BHARAT HEAVY ELECTRICALS LIMITED
PROJECT ENGINEERING MANAGEMENT, NOIDA

CORRIGENDUM- 05

PROJECT	:	3X660 MW NPGCPL NABINAGAR STPP (FGD PKG)
PACKAGE	:	MISC. TANKS(SITE FABRICATED)
ENQUIRY NO	:	PE/PG/NB2/E-6402/2019 Dated. 05.03.2020
SUBJECT	:	PRE- BID CLARIFICATION

PROJECT:	3X660MW NABINAGAR STPP (SYSTEM : FLUE GAS DESULPHURIZATION)		
CUSTOMER:	NTPC LIMITED. (A GOVERNMENT OF INDIA ENTERPRISE)		
DEPT. CODE:	DRN	NAME	SIGN
M	CHD		
APPD.			
TITLE:	GENERAL ARRANGEMENT AND DATA SHEET OF AUXILIARY ABSORBENT (STORAGE) TANK		
DRAWING NO.	SKETCH-06	SH 01 OF 02	REV.00

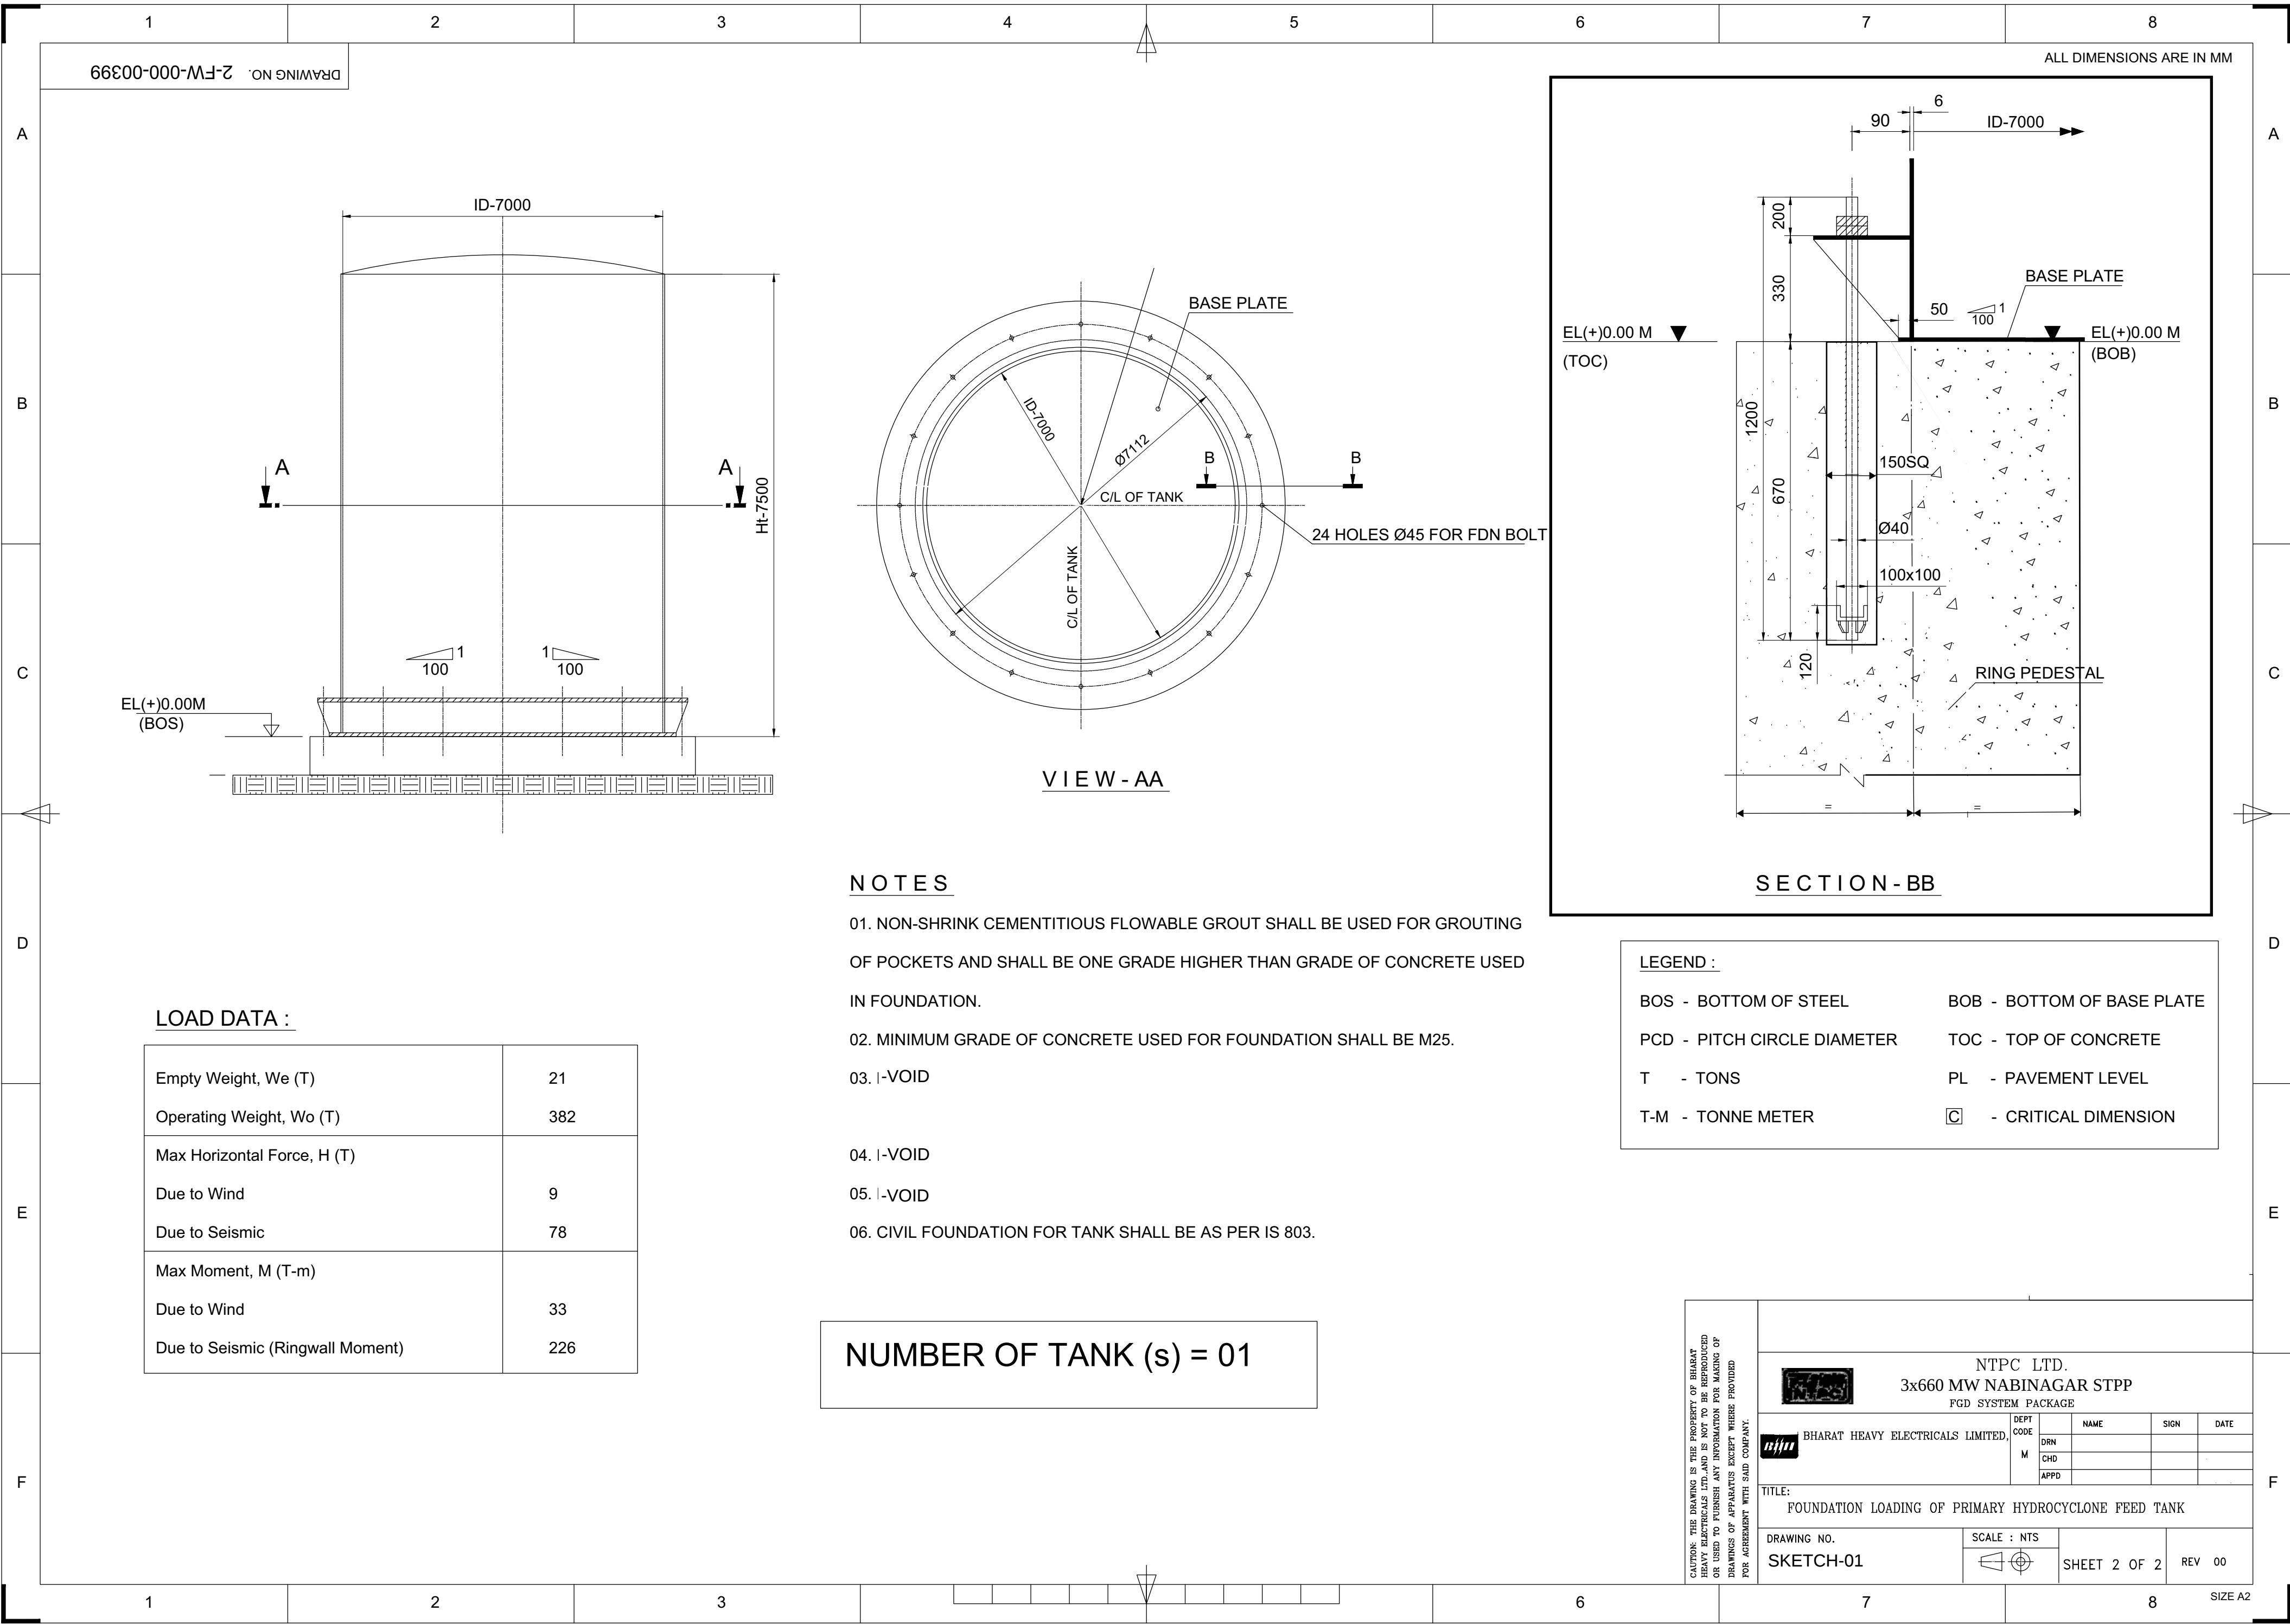
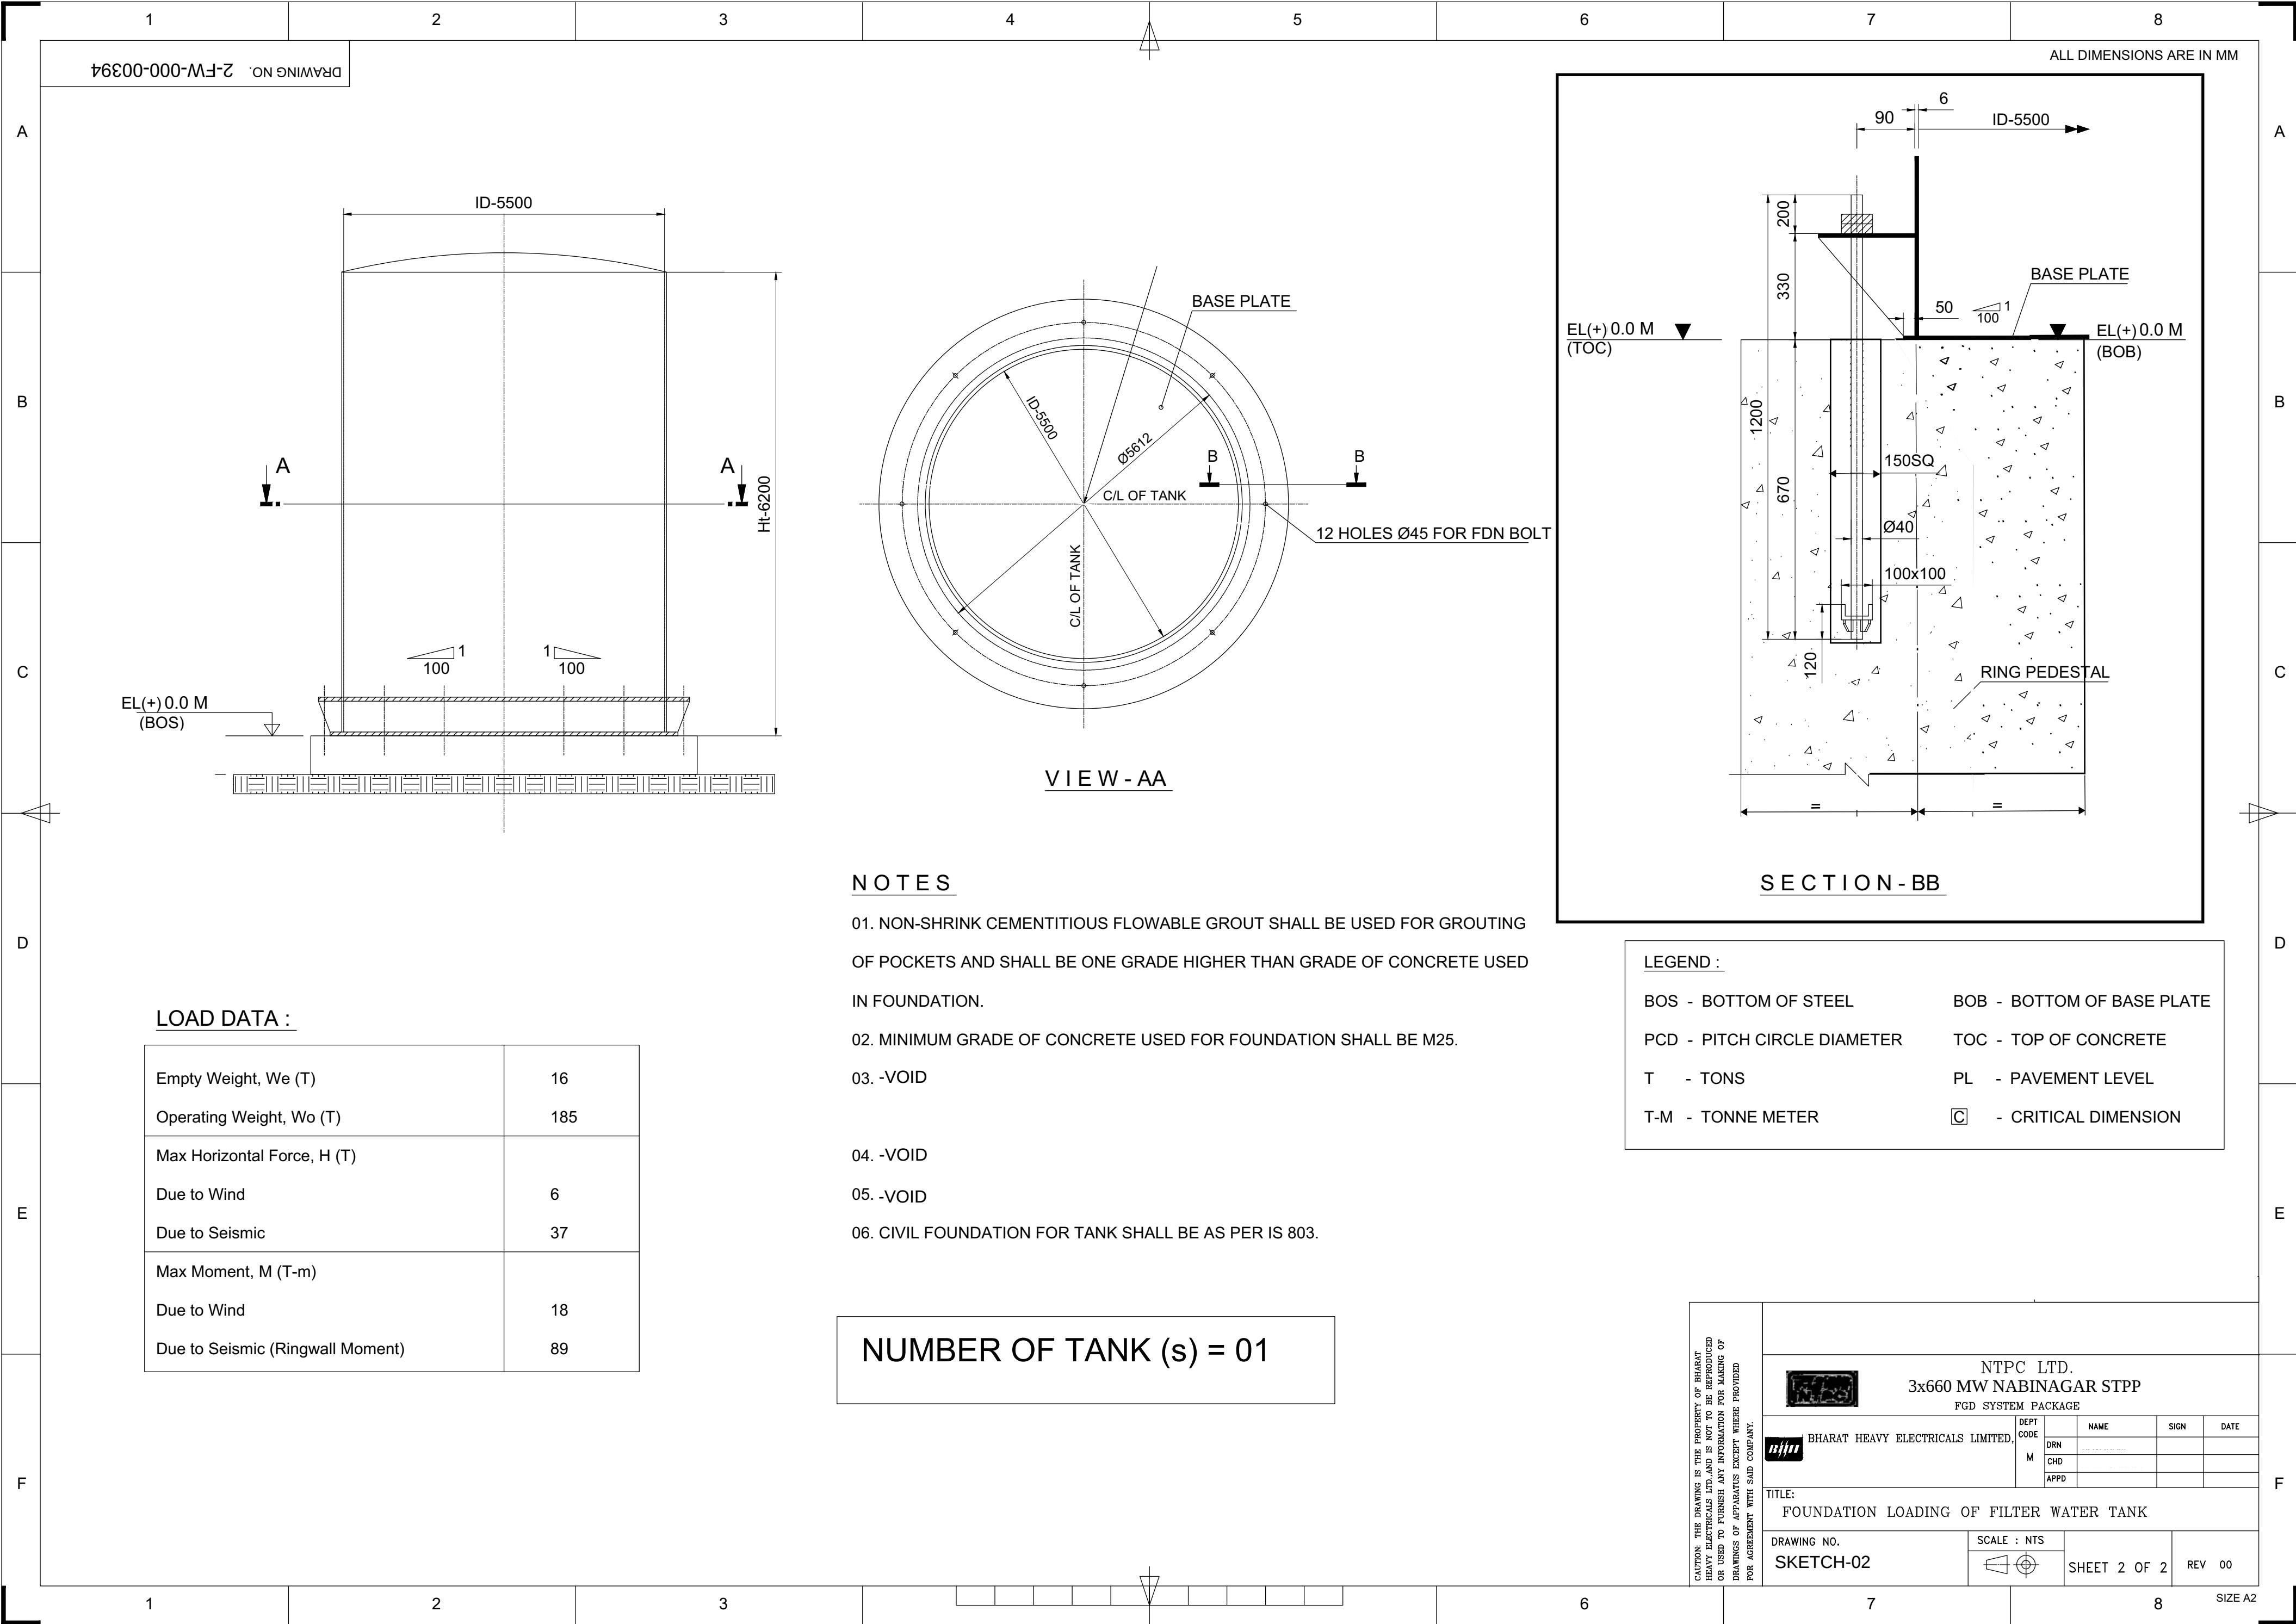
MISC. TANKS (SITE FABRICATED) at 3 X 660 MW NPGCPL NABINAGAR STPP (FGD PKG)			Tender No. PE/PG/NB2/E-6402/2019	
Pre Bid Clarifications Reply				
S.No.	Section/Clause/ Page No.	Statement of the referred clause	Clarification required	BHEL Reply
24	PE-TS-457-167-A101Part9 / drwng nos. Sketch-6	In the given drawing for Auxillary Absorbent tank , only one number of agitator is shown	Both this statement is contradicting. Please clarify regarding quantity of agitator need to be considered per tank for Auxillary Absorbent tank.	Please refer the revised GAD of Aux Absorbent Tank indicating horizontal/ side entry Agitator (annexure-III attached herewith). Please refer Annexure -IV for the revised Foundation Loading Drawing no Sketch-1 Sheet 2 of 2, Sketch-2 Sheet 2 of 2, Sketch-3 Sheet 2 of 2, Sketch-4 Sheet 2 of 2, Sketch-5 Sheet 2 of 2, Sketch-6, Sheet 2 of 2, Sketch- 7 Sheet 2 of 2, Sketch-8 Sheet 2 of 2, Sketch-9 Sheet 2 of 2.
